Subject	East West Rail Phase 1 – Arup responses to Paul Buckley’s correspondence dated 6th March 2015		
Date	21 April 2015	Job No/Ref	237838-00/H03-OB

1 Introduction

Oxford City Council (OCC) as a Local Planning Authority (LPA) is in receipt of two applications for the discharge of Condition 19 of the East West Rail Link Phase 1, in respect of a Vibration Scheme of Assessment (VSoA). The VSoA comprises a Plain Line Report, a S&C report and a covering letter, dated 16th May 2014^{1,2}. Condition 19 requires that, when submitted, a VSoA must be accompanied by a report from an Independent Expert (IE) which comments on the robustness of the vibration aspects.

Figure 2. Simple calculation of relative vibration responses to a constant amplitude (unit) load at 10 m.

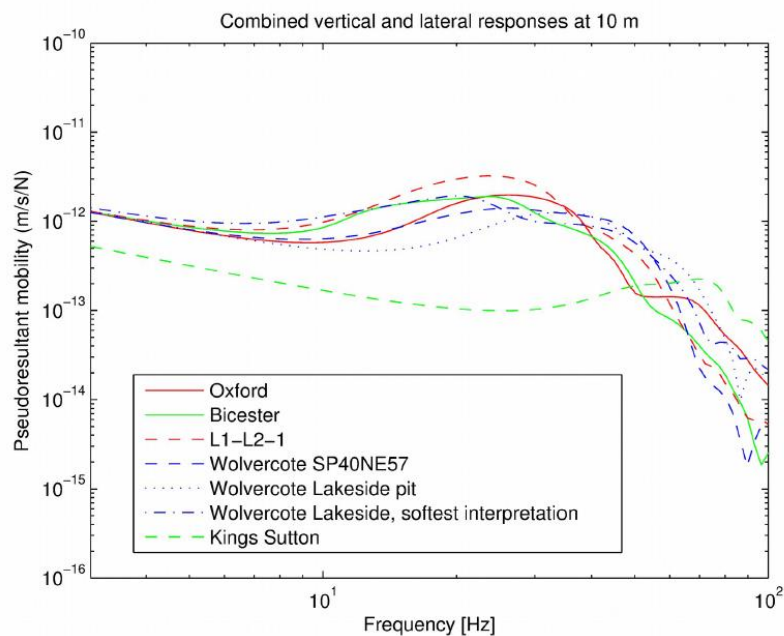
“The Oxford, Bicester and Kings Sutton responses are those presented in my notes made for the LPAs in February 2013. The significantly lower response at King Sutton means that a prediction scheme based on these measurements would likely predict levels of vibration below what could be expected alongside the Bicester - Oxford line. In comparison to this the curves representing locations closer to the Oxford - Bicester line are much closer together. They all come together at very low frequency because, at low frequency, the vibration transmission depends on the deeper situated material and I have seen that throughout the whole area the ground becomes the same stiff Oxford clay at some depth. No other, much deeper, rocky material is expected to have influence in the frequency range we are interested in.

For Wolvercote, within that line, specifically I have made three calculations. One based on my best interpretation of the SP40NE57 bore hole and two, more uncertain in interpretation, based on the lakeside pit information (SP41SE157); a ‘best’ interpretation and one that errs on the side of assuming soft materials.

For the L1/L2 site the borehole information is clear but I have erred on the side of caution by assuming a compacted gravel shear wave speed for the gravel layers that are labelled as river terrace deposits. A higher response is indicated at the L1/L2 site over most of the frequency range. Only the more pessimistic interpretation of the Lakeside data exceeds this slightly.”
